# Access Compliance Report

## Public Rights-of-Way

### (Curb Ramps)

Intersection ID: 4051	Main Street: MT_ISLE_HARBOR_DR	Cross Street: SHADY_REACH_LN	Location: S
ADA ID: 5AC32A6ECD8D	Ramp Type: Perp	Initial Pass/Fail: Fail	Overall Compliance: No
			Severity Score: 10

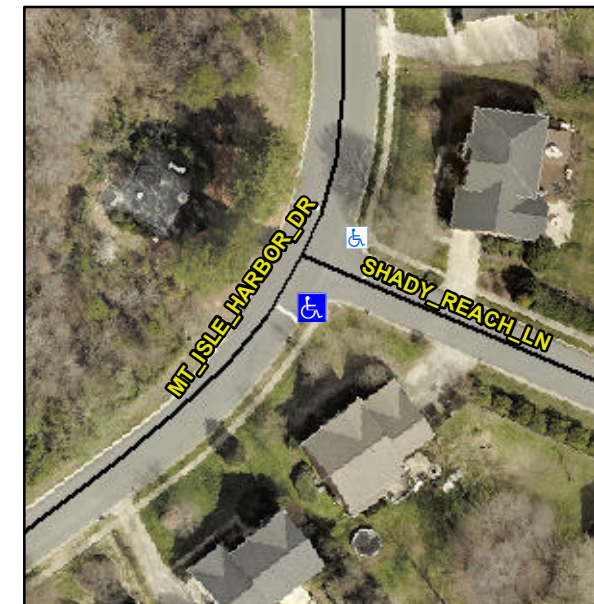
**R304.5.1, R304.5.3**

Compliance	Description	Data	Compliance	Description	Data
N/A	Ramp Length (in)	54.0	Yes	Ramp Slope (%)	6.6
No	Ramp Width (in)	47.0	No	Ramp XSlope (%)	3.0
N/A	Flare Type LT	N/A	N/A	Flare Type RT	N/A
N/A	Flare Slope LT (%)	N/A	N/A	Flare Slope RT (%)	N/A
N/A	Flare Traversable LT?	N/A	N/A	Flare Traversable RT?	N/A
N/A	Landing Length (in)	N/A	N/A	DWS Provided?	N/A
N/A	Landing Width (in)	N/A	N/A	DWS Contrast?	N/A
N/A	Landing Slope (%)	N/A	N/A	DWS Length (in)	N/A
N/A	Landing X Slope (%)	N/A	N/A	DWS Full Width?	N/A
N/A	Landing Curb? (Y/N)	N/A	N/A	DWS Offset (in)	N/A
N/A	Shared Landing?	N/A			
N/A	Gutter Ponding?	N/A	N/A	Gutter Slope (%)	N/A
N/A	Gutter Lip Ht (in)	N/A	N/A	Gutter X Slope (%)	N/A
N/A	Painted X Walk1?	No	N/A	Painted X Walk2?	N/A
	X Walk 1 Direction	To NE		X Walk 2 Direction	N/A
N/A	X Walk 1 Width (in)	N/A	N/A	X Walk 2 Width (in)	N/A
	X Walk 1 Slope (%)	1.2		X Walk 2 Slope (%)	N/A
	X Walk 1 X Slope (%)	1.0		X Walk 2 X Slope (%)	N/A

**Remove & Replace Entire Ramp.**
